# P802.3bq D2.3 & P802.3bz D1.1 Comments for ad hoc Review

IEEE P802.3bz ENUCA and P802.3bq RxCMNR ad  
hoc

“a” version updated November 5<sup>th</sup>, 2015 to reflect  
ad hoc discussion of .bq and .bz comments  
*(ad hoc discussion is noted in this text style)*

Figure 113A–2—Cross-section of cable clamp

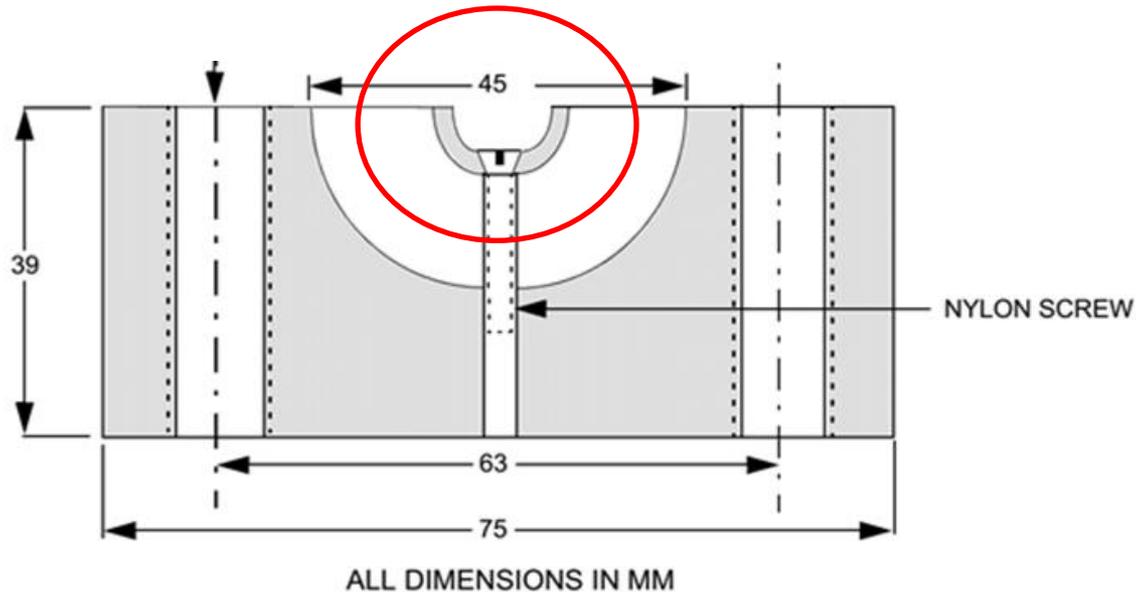
- Comment #57 - As shown in Figure 113A–2 the inner conductor on the bottom half of the clamp extends slightly (~ 0.1mm) - this is not shown in the figure
- Suggested Remedy - Delete "As shown in Figure 113A-2", capitalize "the“

As shown in Figure 113A–2 the inner conductor on the bottom half of the clamp extends slightly (~ 0.1mm) above the dielectric to ensure there is good electrical connection with the inner conductor of the top half of the clamp along the full length of the conductor when the two halves are clamped together.

Proposed Accept. Note – A similar discrepancy exists in Annex 40B, Figure 40B-2.  
*Ad hoc agreed with the suggested remedy.*

**Figure 113A-3—Cable clamp validation test configuration**

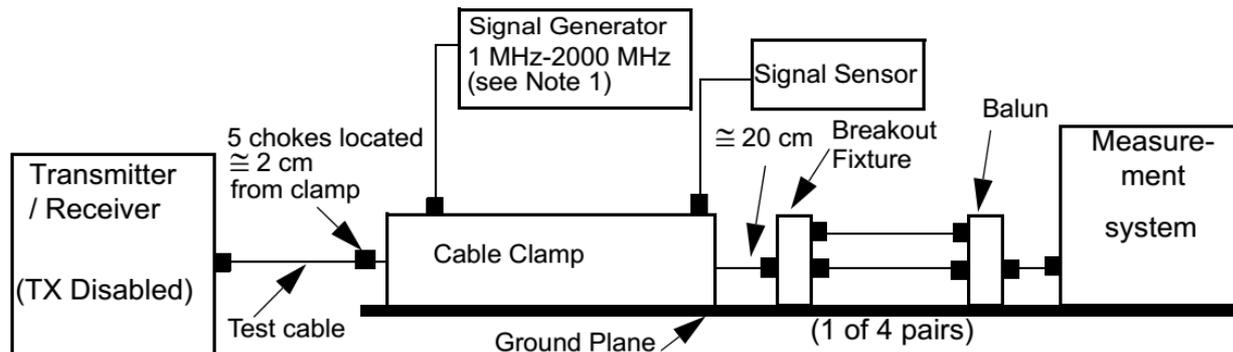
- Comment #TBA - should be plural - two are shown
- Suggested Remedy - change to Oscilloscopes, power meters or spectrum analyzers
- Since the measurements could be performed sequentially, suggest keeping text as-is. The text does not preclude using more instruments.

*Commenter indicated that the comment will be withdrawn.*

**Figure 113A-4—Cable clamp test configuration**

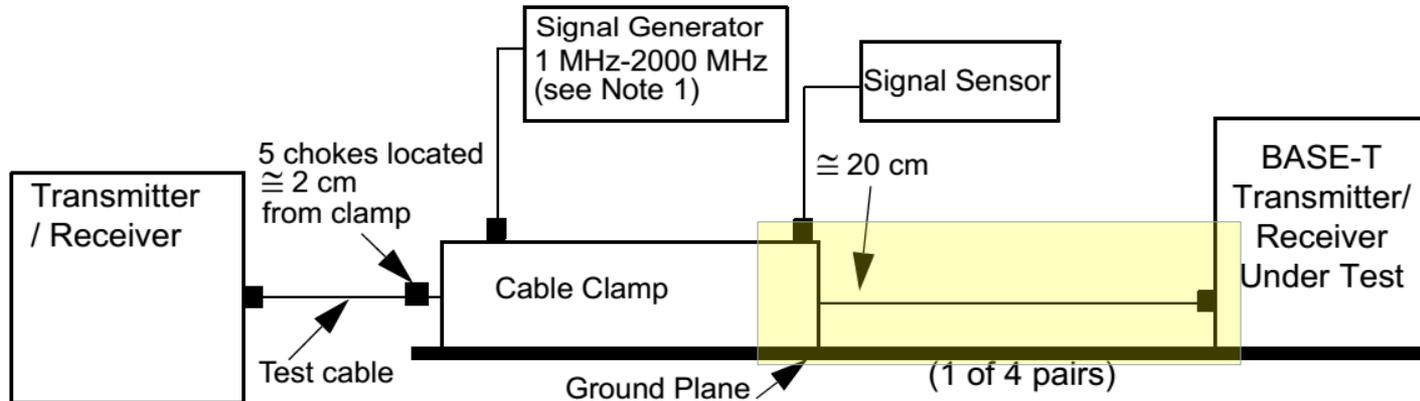
- Comment #90 - It would be better to see this image redrawn so it does not appear that the cable was pulled out an extra length from its original validation position.
- Suggested Remedy– as suggested
- Both figures define the length; the figures are consistent with Clause 40. Suggest not changing.

*Discussion as above. Commenter agreed with the observation that the figures are consistent with Clause 40 and that both indicate the length of the cable.*
